## Vehicle Speed Sensor VN, VAH, VHD

### FSB 386-007, Vehicle Speed Sensor

(November 2014)

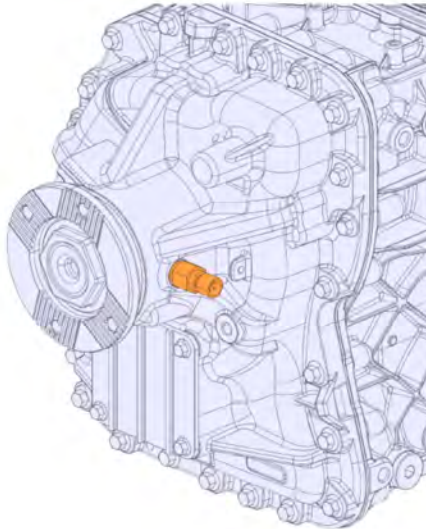
- 1 Secure the vehicle for service by parking it on a flat level surface, applying the parking brake, chocking the rear wheels, and placing the transmission in neutral.
- 2 Disconnect all cables from the negative (ground) battery terminal to prevent personal injury from electrical shock and prevent damage to electrical components.
- 3 Disconnect the harness from the vehicle speed sensor (VSS) located at the rear of the transmission.

W3094986

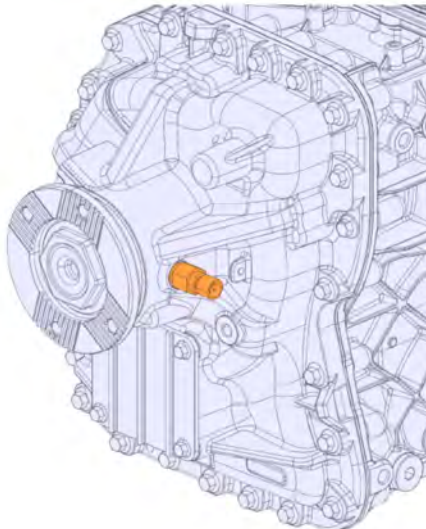
- 4 Remove the VSS from the transmission.

**Note:** If sensor part number 3171490 is found to have been installed and needs to be replaced, this sensor is also replaced with 22387296.

**Note:** If a gasket or shim is present between the sensor and transmission discard it  
**DO NOT** reuse with new sensor.

- 5 Install the new VSS onto the transmission and secure (part # 22387296).

- 6 Tighten the VSS to  $25 \pm 5$  Nm ( $18 \pm 3.7$  ft-lb)
- 7 Connect the harness to the VSS.
- 8 Install all the previously removed cables to the negative (ground) battery terminals.
- 9 Remove the wheel chocks.
